From: [REDACTED]
To: [Baths Quays Links](#)
Subject: consultation 25-052 "Bath City Centre walking, wheeling and cycling proposals - statutory consultation"
Date: 11 December 2025 12:48:48
Attachments: [image001.png](#)
[image002.png](#)
[image003.png](#)

From: [REDACTED]
To: [Baths Quays Links](#)
Subject: TRO Ref. 25-052 VARIOUS ROADS, CENTRAL AREA, BATH, PROHIBITION OF STOPPING, WAITING, LOADING AND PARKING PLACES
Date: 08 January 2026 14:36:18
Attachments: [3174 The Min Bath Technical Note Servicing Deliveries Nov25 Final.pdf](#)
[3174 26.01.07 Upper Borough Walls TRO 25-052 PFP Reps Final.pdf](#)

PERMANENT TRAFFIC REGULATION ORDER, UPPER BOROUGH WALLS – TRO REF 25-052

TECHNICAL NOTE ON HOTEL SERVICING AND DELIVERIES

2021 Parking and Loading Bays and Restrictions

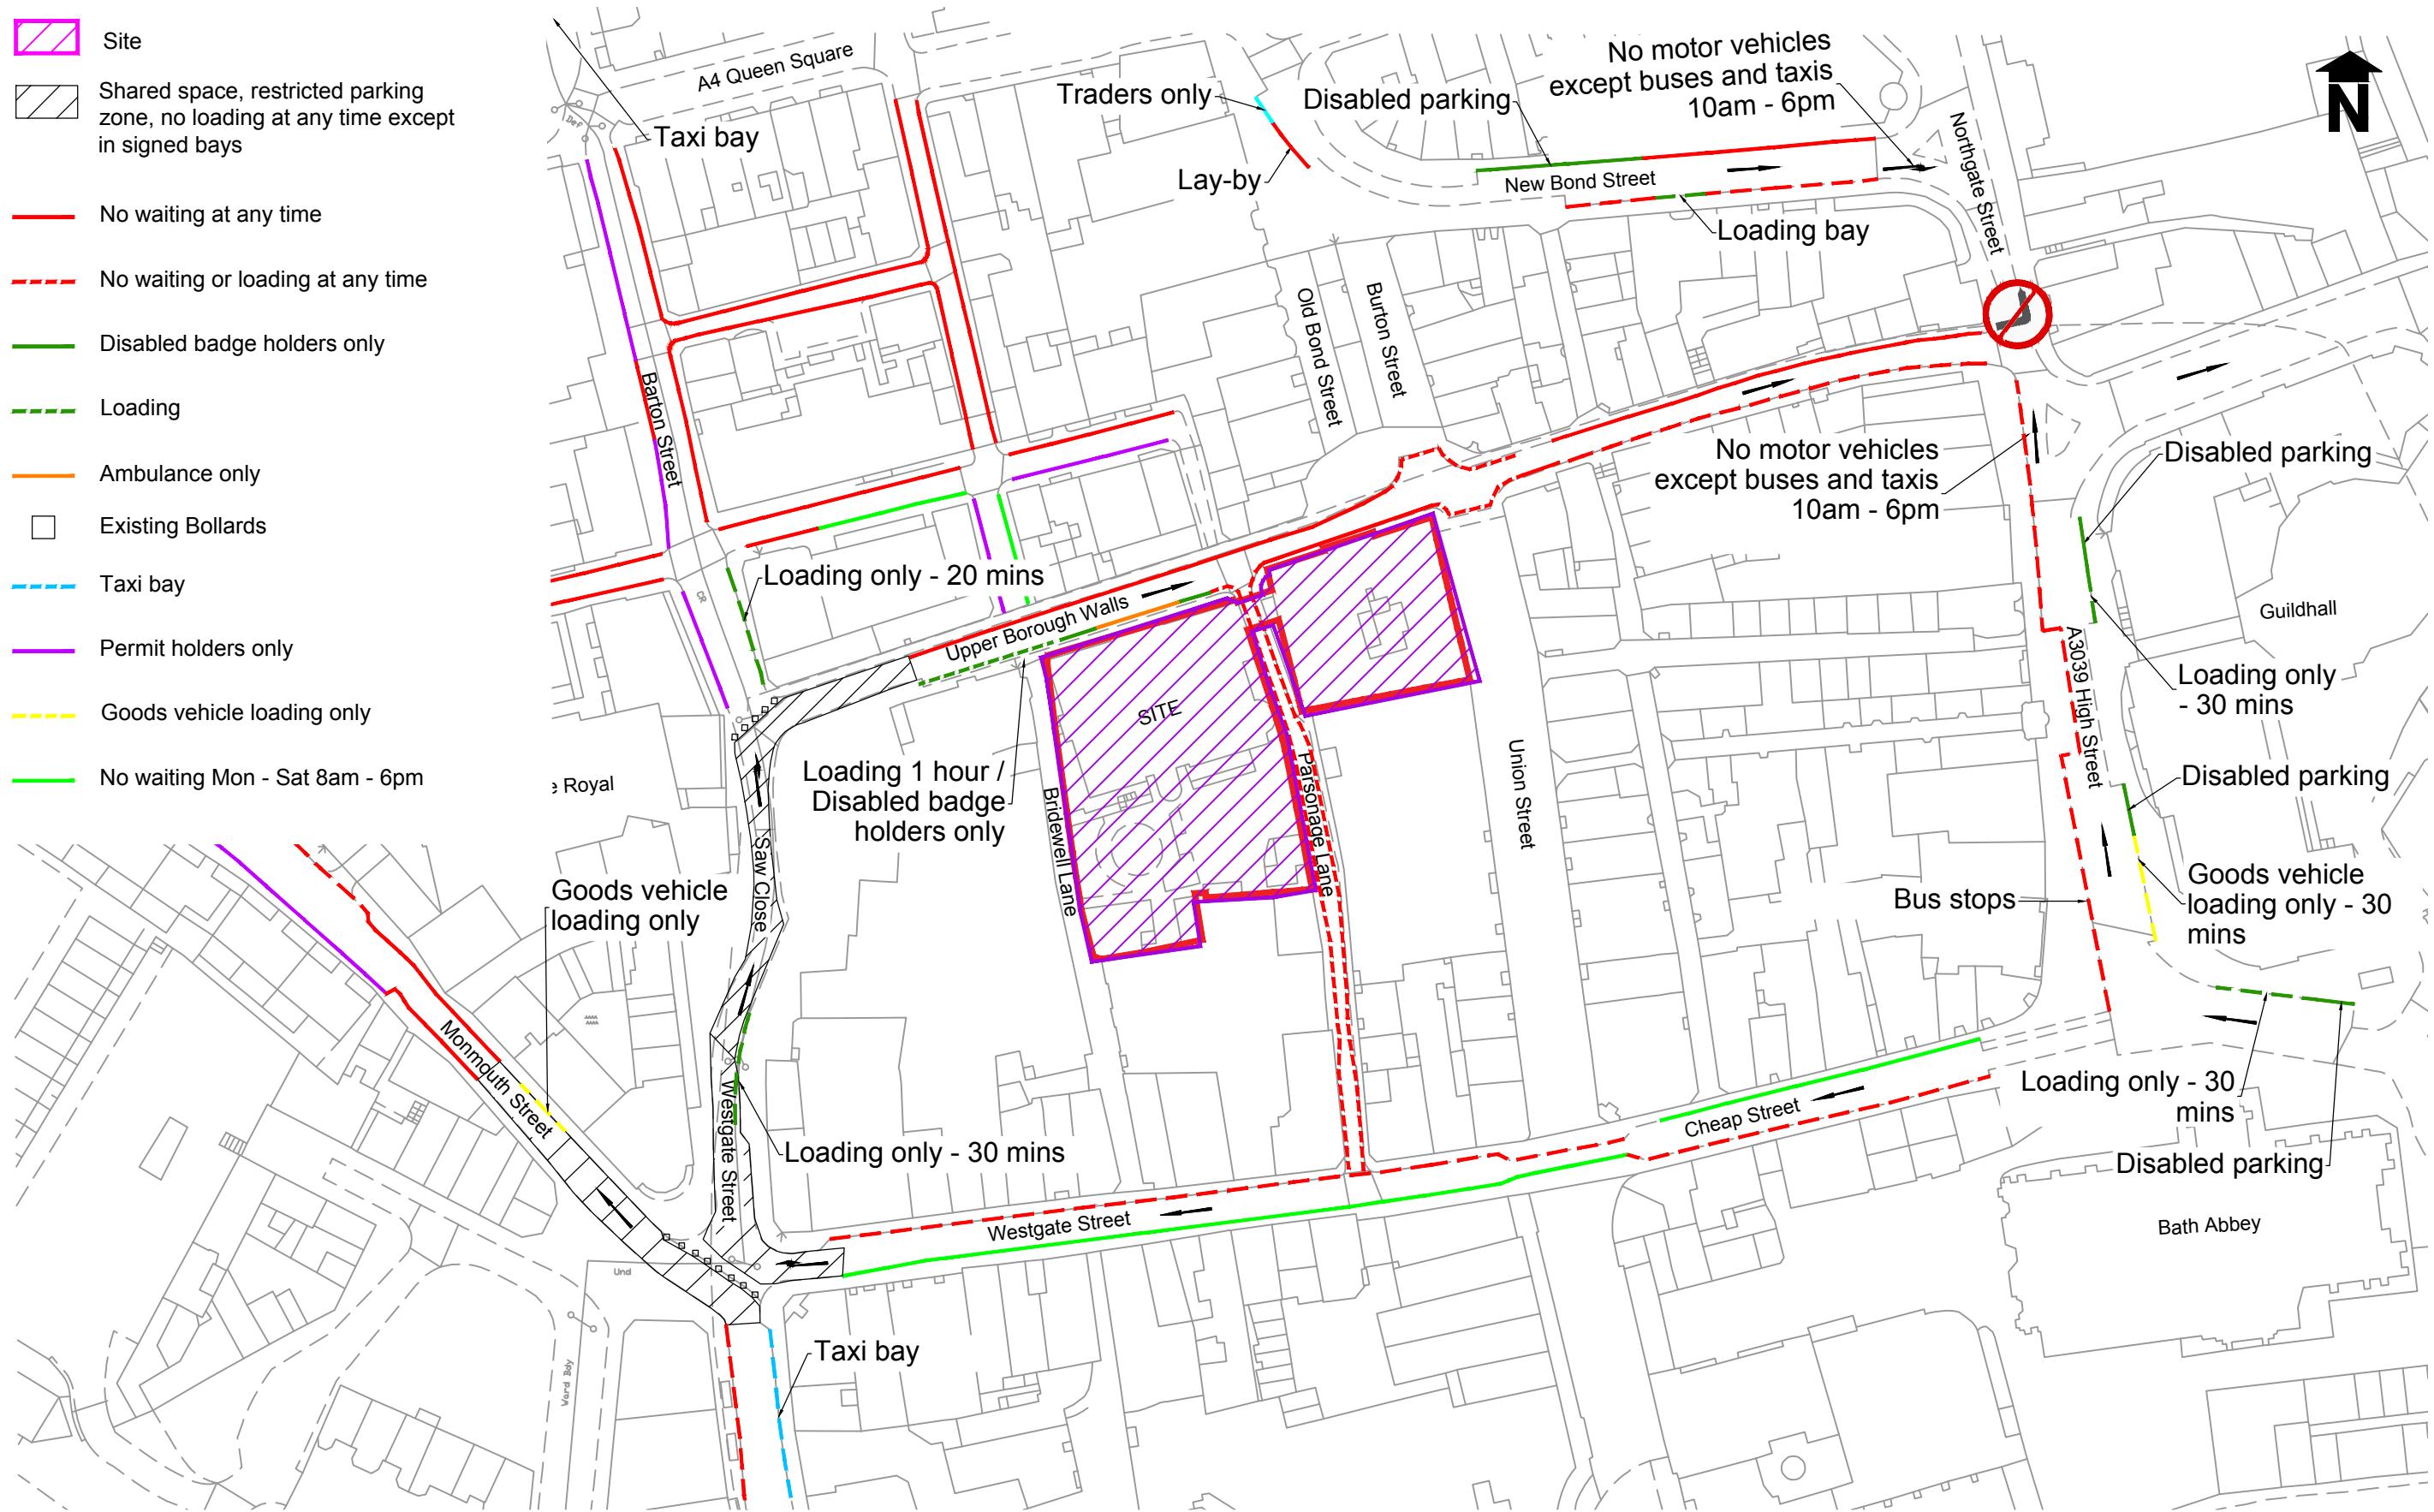
- 1.2.5 The parking and loading bay and restrictions presented in the TS are shown on the drawing as Attachment 1.
- 1.2.6 Traffic surveys carried out in 2019 as part of the planning application process, showed there were the following number of goods vehicles recorded stopping on UBW outside The Mineral Hospital over a 24-hour period. These deliveries are now taking place within a shorter timeframe due to the city centre traffic restrictions between 10:00 and 18:00.

WSP CRSTS Phase 1 Drawing

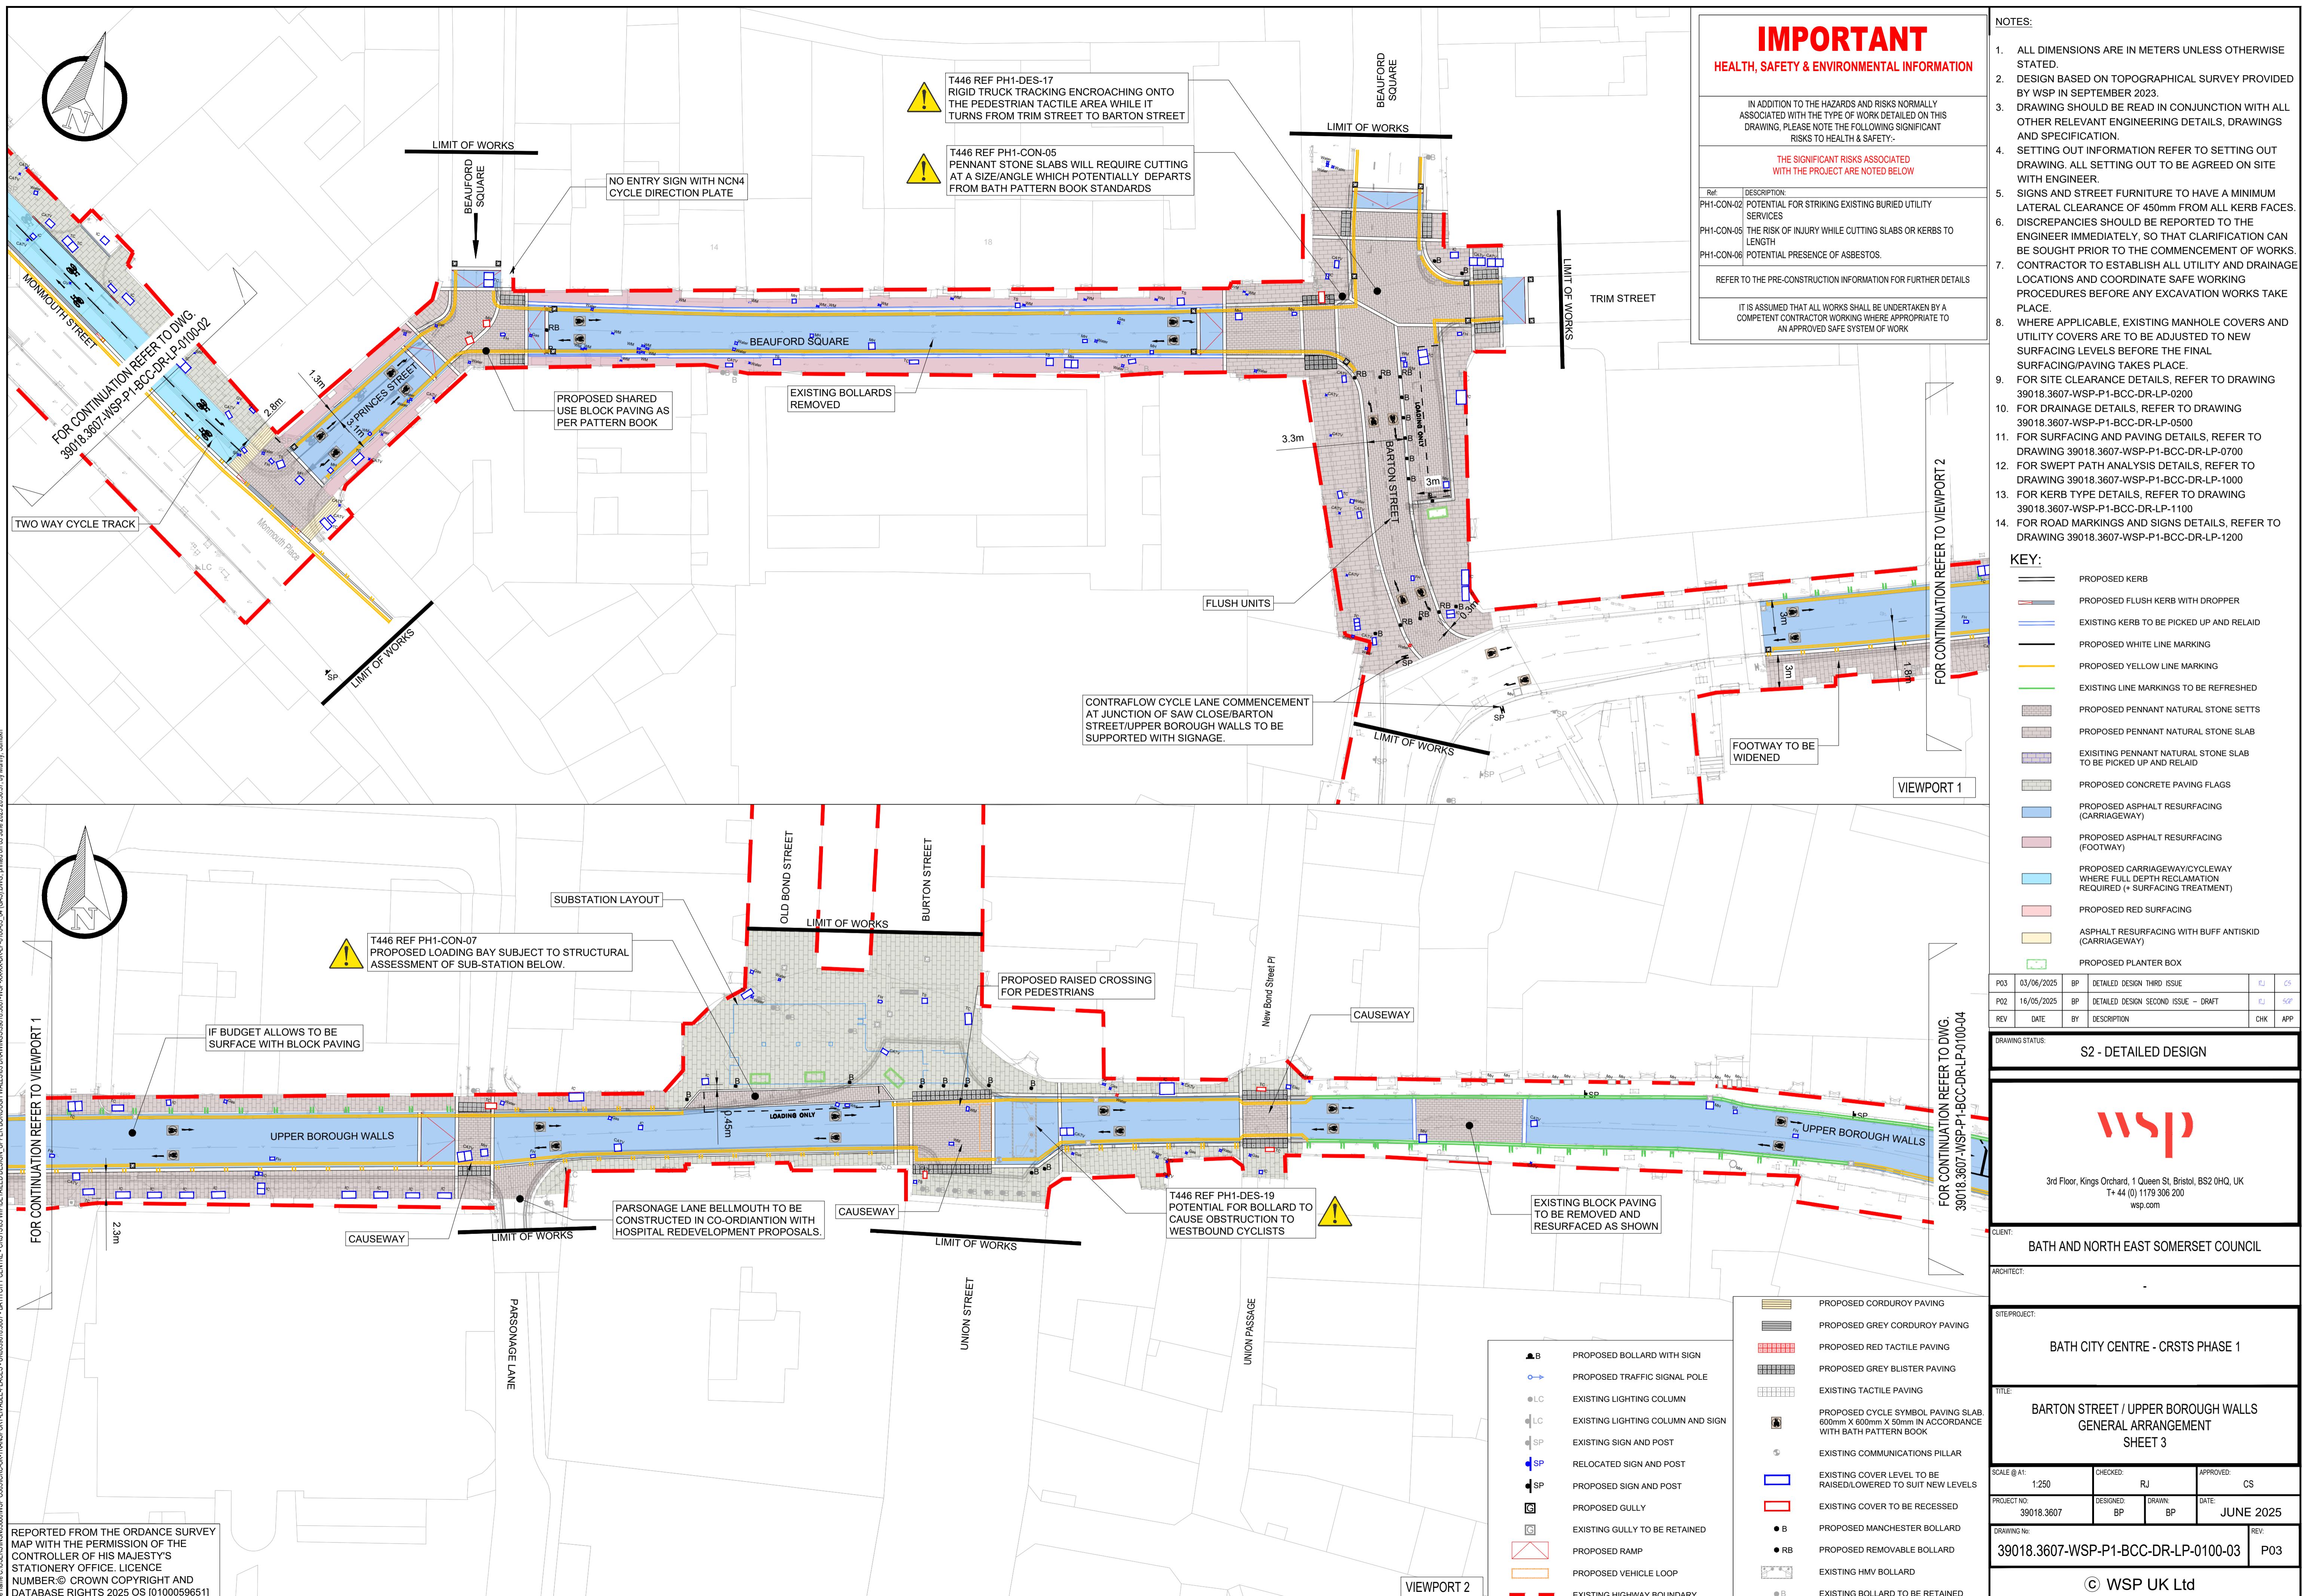
3.1.3 There are no loading bays proposed on UBW adjacent to the West block of the site. A loading bay is proposed on the northern side of UBW opposite the East block of the site, subject to structural assessment of the sub station below. The loading bay is some 15m long and 1.8m deep. It is partly within the carriageway. With an HGV parked in the loading bay there would be an effective carriageway width of approximately 3m. This loading bay would be for all local businesses including those on UBW, Union Street, Old Bond Street and Burton Street.

4.2.1 The CRSTS Phase 1 would not permit any loading or unloading on UBW, except in one dedicated loading bay opposite the East block of the site next to Old Bond Street and Burton Street, but this is not guaranteed.

4.2.2 The single loading bay opposite the East block would not be sufficient for the level of servicing and delivery activity that currently and in the future would take place on UBW. Delivery and servicing can only take place between the hours of 18:00 and 10:00 and there would be pressure on the one loading bay during the restricted time period, leading to congestion and potential highway safety issues with vehicles attempting to stop on the footway or in inappropriate locations.

5.1.3 The CRSTS Phase 1 scheme bans all loading from UBW, except at one loading bay, which itself is not guaranteed due to structural issues with sub station underground.
